STAFF REPORT 7-10-2019 MEETING
APPLICATION NUMBER: 19-6321
ADDRESS: 110 SPROAT
HISTORIC DISTRICT: EDDYSTONE HOTEL
APPLICANT: BRIAN REBAIN
DATE OF STAFF VISIT: 7/8/2019

RE: Eddystone Hotel - HDC Submission

110 SPROAT (EDDYSTONE) FACADE RESTORATION

SOUTH ELEVATION

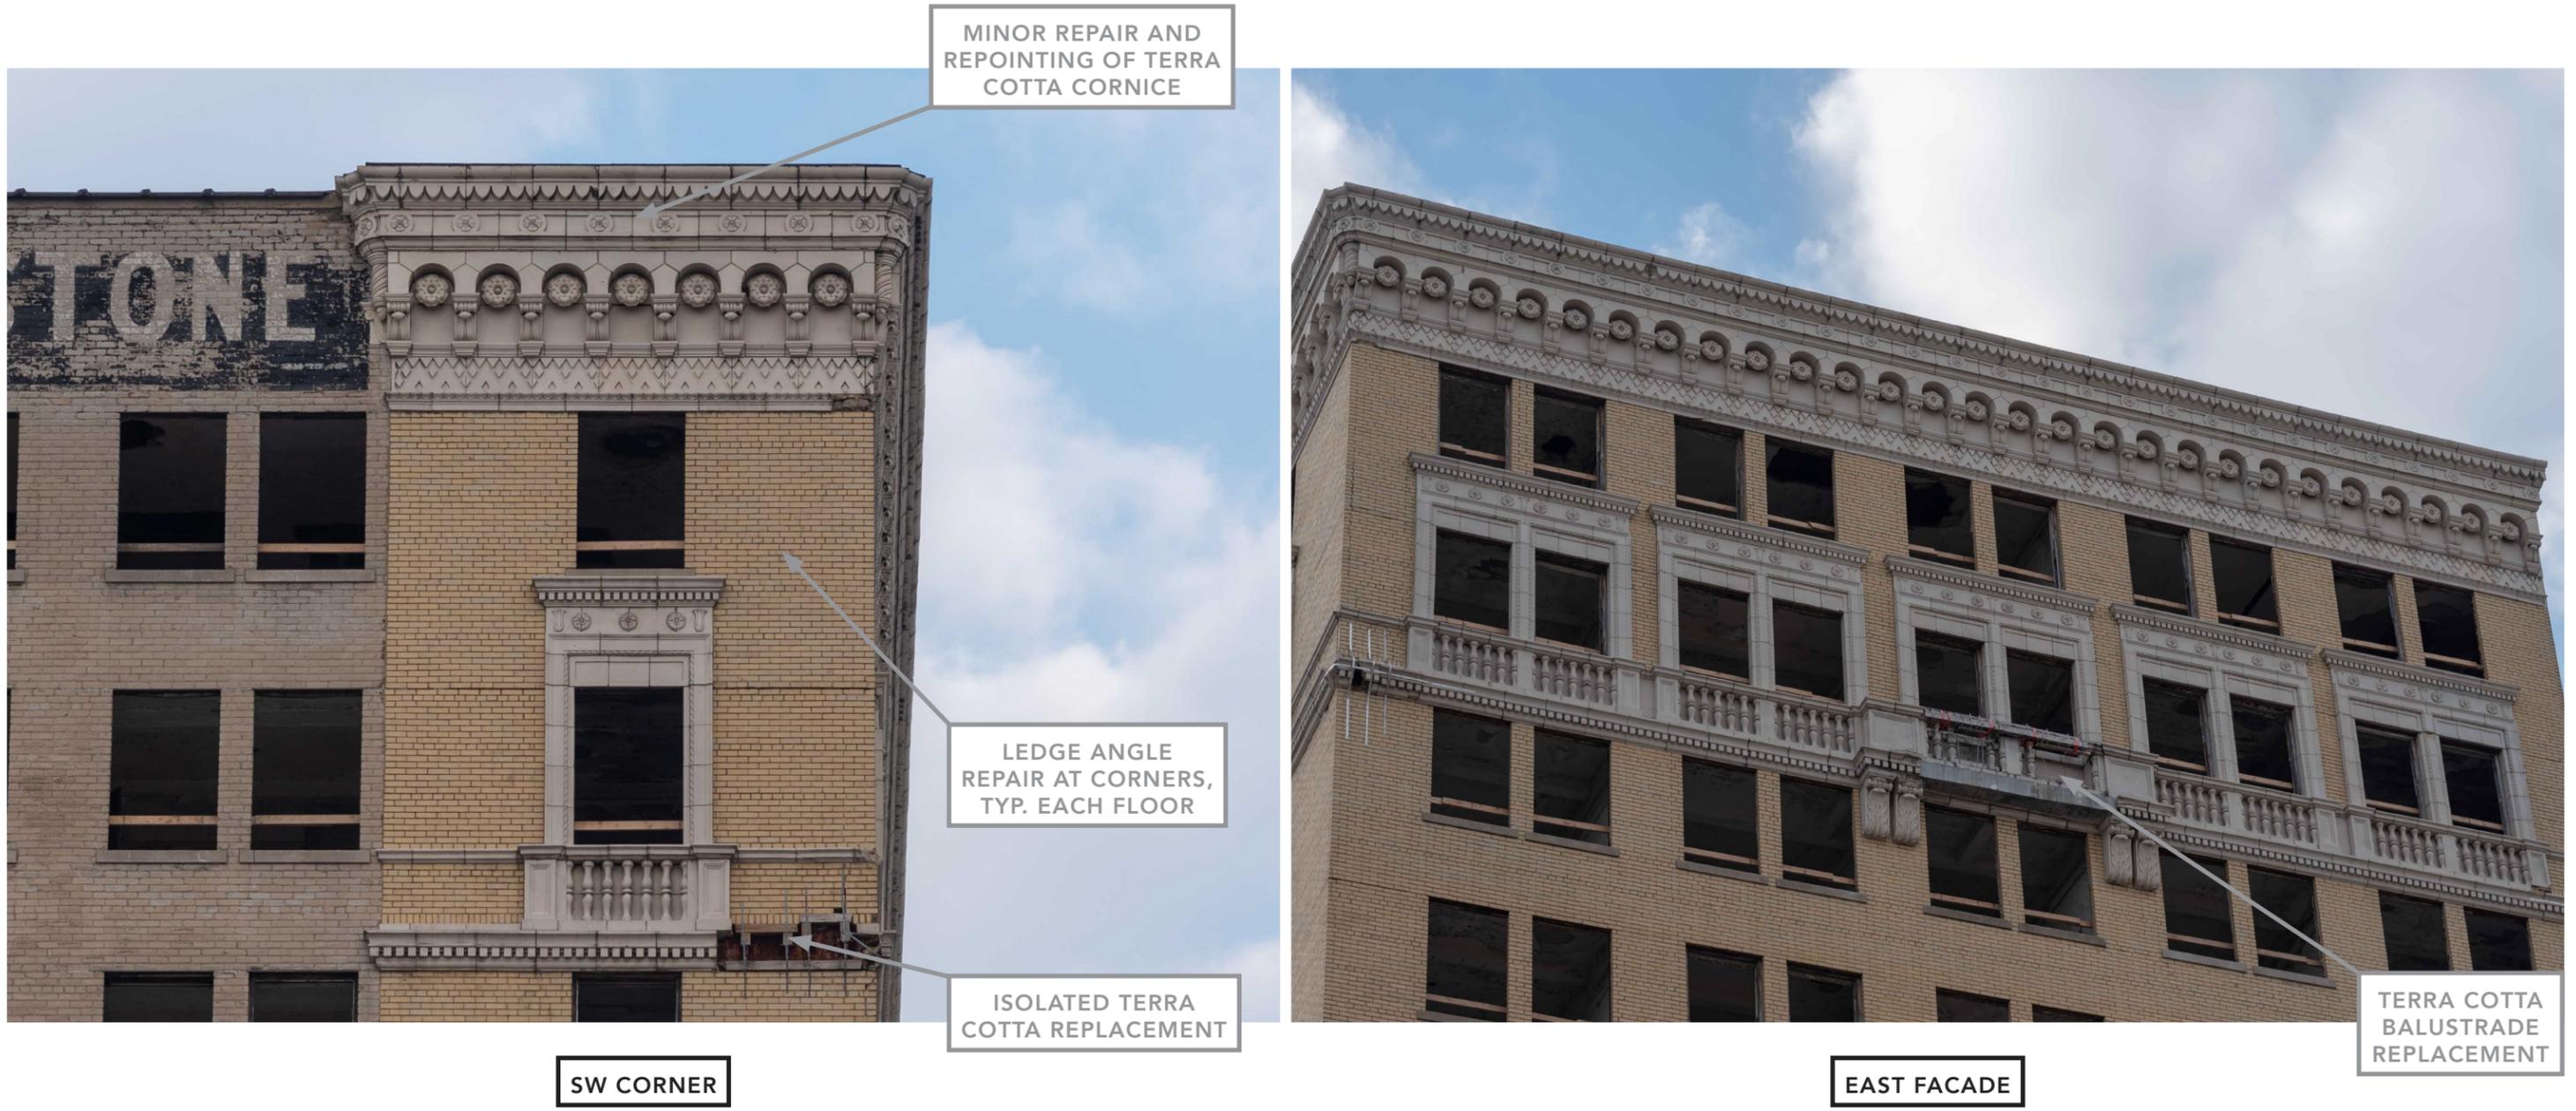
ISSUES: Isolated damage requires unique replacement solutions; very little repetition in components.

RECOMMENDATION: True terra cotta replacement is feasible given limited scope of replacement.

UPPER SOUTH FACADE

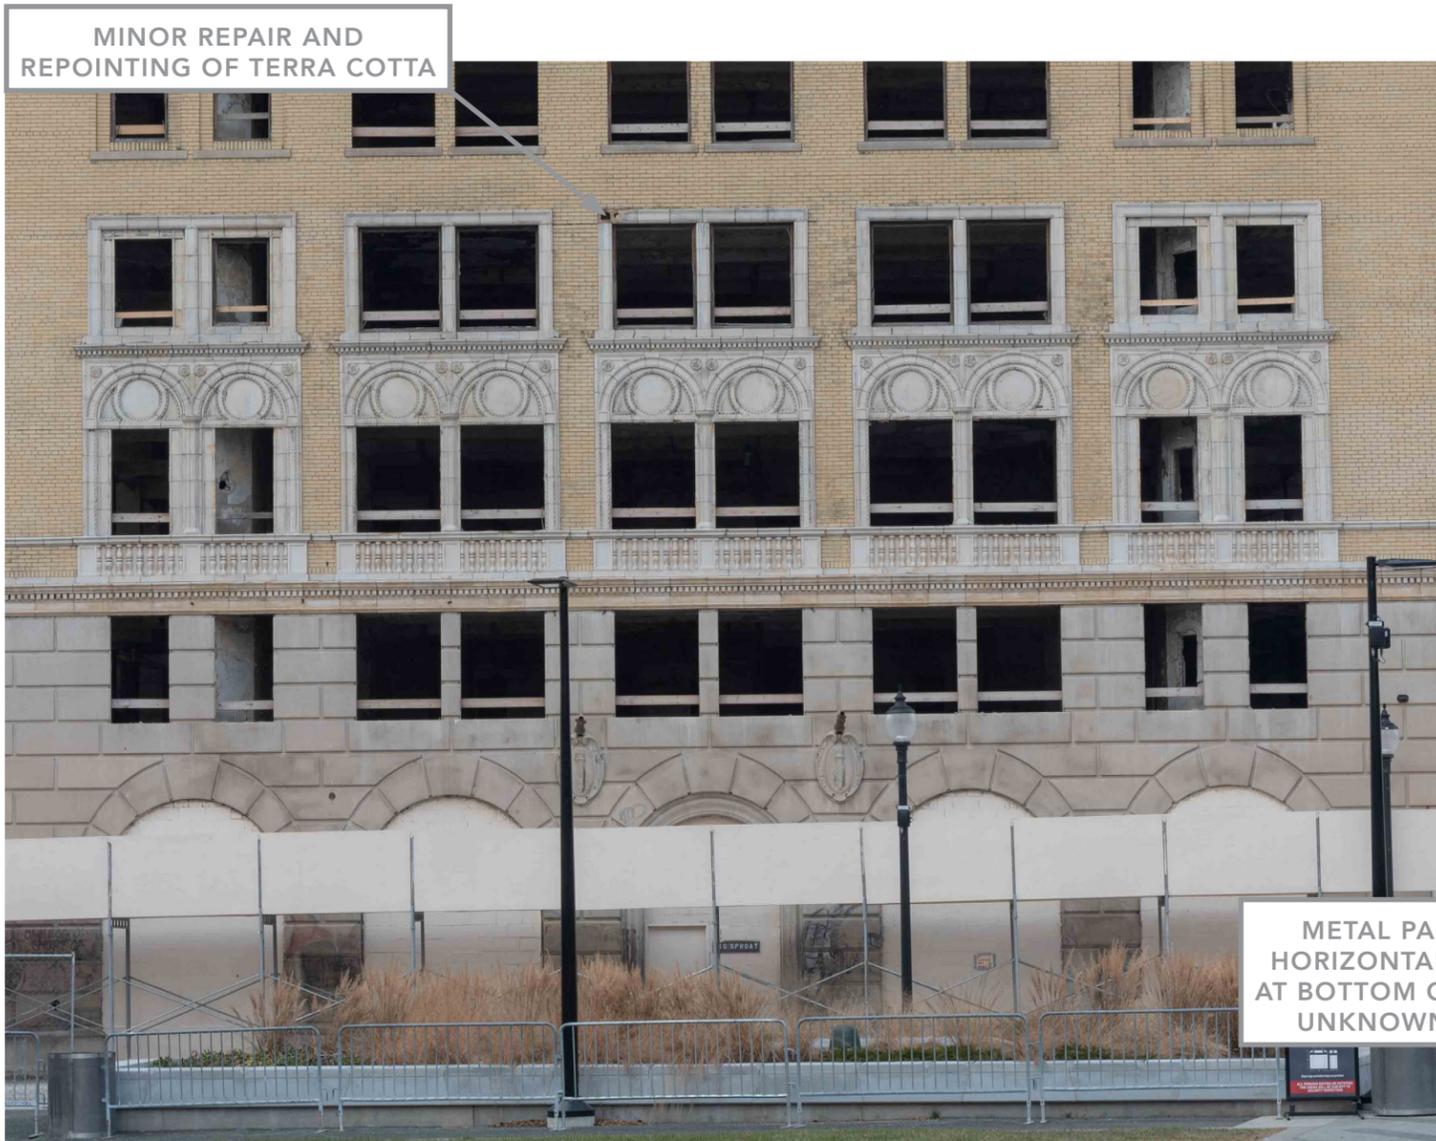
ISSUES: Entire missing balustrade on upper south facade allows for repetitive components and more options.
Unknown condition under metal panning at base of balustrade.

RECOMMENDATION: Bid alternate for terra cotta and fiberglass at balustrade. Price and schedule will be considered. Metal panel to be removed and condition ascertained before final decision on underlying repair.

FIRST FLOOR LIMESTONE - BEFORE

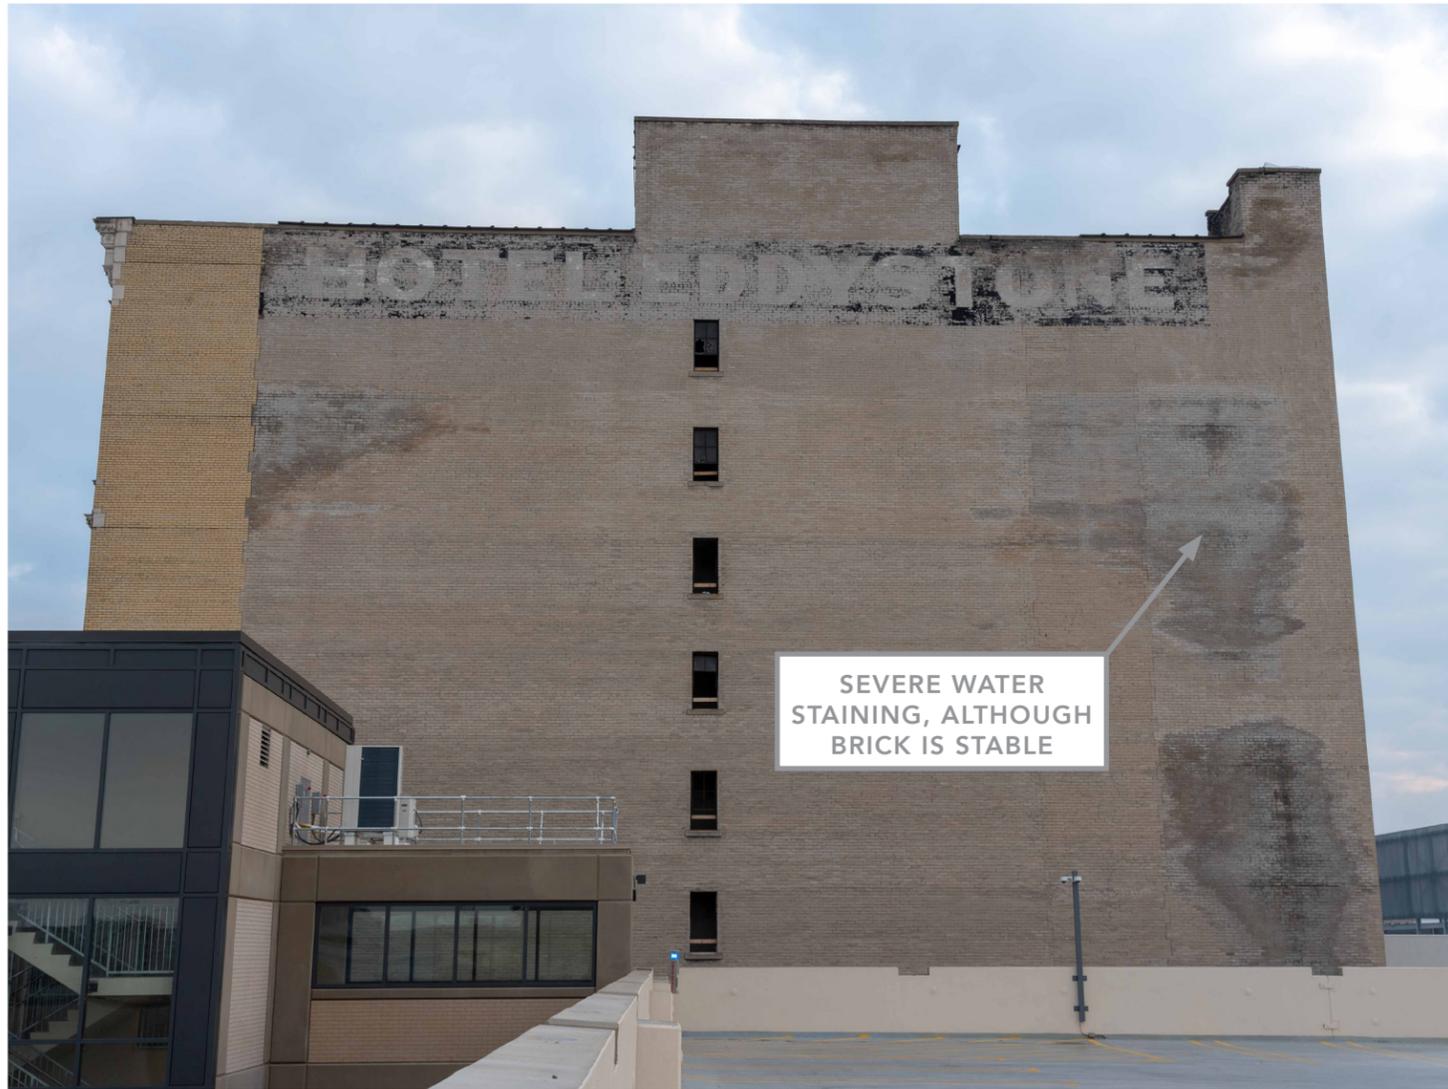
ISSUES: The initial limestone cleaning method could not remove entirety of graffiti

RECOMMENDATION: Quintek Corporation's Rotec Vortex Cleaning System
